Access Compliance Report

Public Rights-of-Way

(Curb Ramps)

Intersection ID: 9741	Main Street: CADMIUM_CT	Cross Street: CASA_CT	Location:	E
ADA ID: 55CD26C1451A	Ramp Type: Perp	Initial Pass/Fail: Fail	Overall Compliance: No	Severity Score: 10
Codes/Mitigation Info/Possible Solution		Field Measurements/Component Compliance

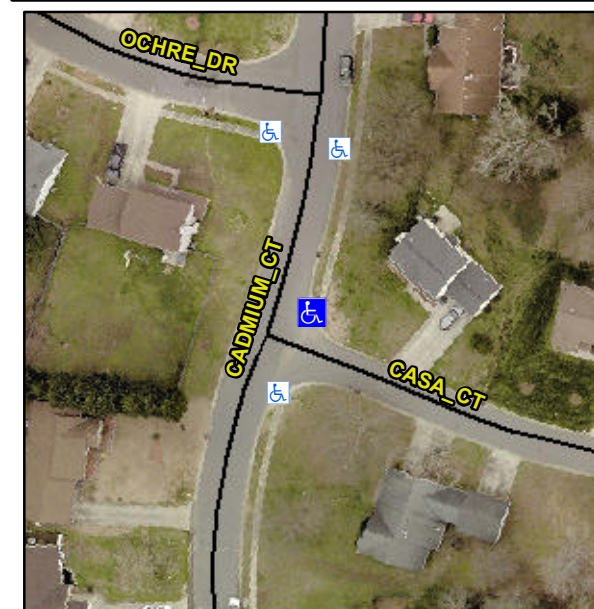
Not Found, R304.5.1, R304.5.3

Compliance	Description	Data	Compliance	Description	Data
N/A	Ramp Length (in)	56.5	Yes	Ramp Slope (%)	6.2
No	Ramp Width (in)	47.0	No	Ramp XSlope (%)	5.0
N/A	Flare Type LT	N/A	N/A	Flare Type RT	N/A
N/A	Flare Slope LT (%)	N/A	N/A	Flare Slope RT (%)	N/A
N/A	Flare Traversable LT?	N/A	N/A	Flare Traversable RT?	N/A
N/A	Landing Length (in)	N/A	N/A	DWS Provided?	N/A
N/A	Landing Width (in)	N/A	N/A	DWS Contrast?	N/A
N/A	Landing Slope (%)	N/A	N/A	DWS Length (in)	N/A
N/A	Landing X Slope (%)	N/A	N/A	DWS Full Width?	N/A
N/A	Landing Curb? (Y/N)	N/A	N/A	DWS Offset (in)	N/A
N/A	Shared Landing?	N/A			
N/A	Gutter Ponding?	N/A	N/A	Gutter Slope (%)	N/A
N/A	Gutter Lip Ht (in)	N/A	N/A	Gutter X Slope (%)	N/A
N/A	Painted X Walk1?	No	N/A	Painted X Walk2?	N/A
	X Walk 1 Direction	To SW		X Walk 2 Direction	N/A
N/A	X Walk 1 Width (in)	N/A	N/A	X Walk 2 Width (in)	N/A
	X Walk 1 Slope (%)	0.5		X Walk 2 Slope (%)	N/A
	X Walk 1 X Slope (%)	1.1		X Walk 2 X Slope (%)	N/A

Remove & Replace Entire Ramp.
